Access Compliance Report

Public Rights-of-Way

Intersection ID: 54370	Main Street: LONGWALL_LN	Cross Street: CALLONWOOD_DR	Location: SW
ADA ID: 2D8935FBC50A	Ramp Type: Perp	Initial Pass/Fail: Fail	Overall Compliance: No
Severity Score: 13.75			
Codes/Mitigation Info/Possible Solution		Field Measurements/Component Compliance

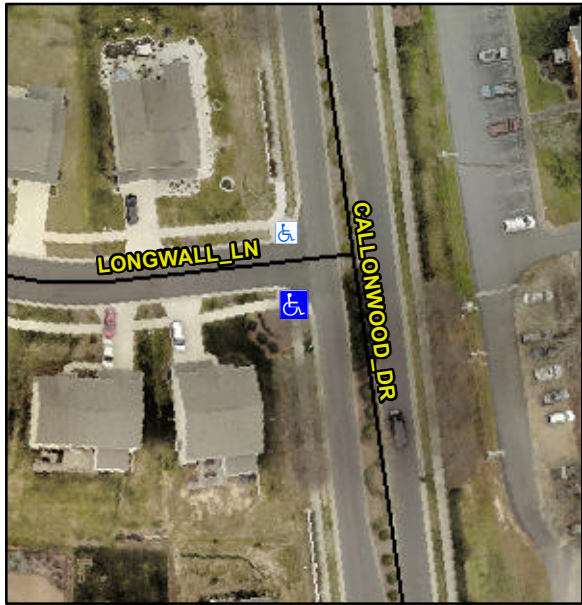
Not Found, R304.2.2, R304.5.3

Compliance	Description	Data	Compliance	Description	Data
N/A	Ramp Length (in)	58.0	No	Ramp Slope (%)	8.7
Yes	Ramp Width (in)	48.0	No	Ramp XSlope (%)	2.1
N/A	Flare Type LT	N/A	N/A	Flare Type RT	N/A
N/A	Flare Slope LT (%)	N/A	N/A	Flare Slope RT (%)	N/A
N/A	Flare Traversable LT?	N/A	N/A	Flare Traversable RT?	N/A
N/A	Landing Length (in)	N/A	N/A	DWS Provided?	N/A
N/A	Landing Width (in)	N/A	N/A	DWS Contrast?	N/A
N/A	Landing Slope (%)	N/A	N/A	DWS Length (in)	N/A
N/A	Landing X Slope (%)	N/A	N/A	DWS Full Width?	N/A
N/A	Landing Curb? (Y/N)	N/A	N/A	DWS Offset (in)	N/A
N/A	Shared Landing?	N/A			
N/A	Gutter Ponding?	N/A	N/A	Gutter Slope (%)	N/A
N/A	Gutter Lip Ht (in)	N/A	N/A	Gutter X Slope (%)	N/A
N/A	Painted X Walk1?	No	N/A	Painted X Walk2?	N/A
	X Walk 1 Direction	To N		X Walk 2 Direction	N/A
N/A	X Walk 1 Width (in)	N/A	N/A	X Walk 2 Width (in)	N/A
	X Walk 1 Slope (%)	6.4		X Walk 2 Slope (%)	N/A
	X Walk 1 X Slope (%)	4.8		X Walk 2 X Slope (%)	N/A

Remove & Replace Entire Ramp.
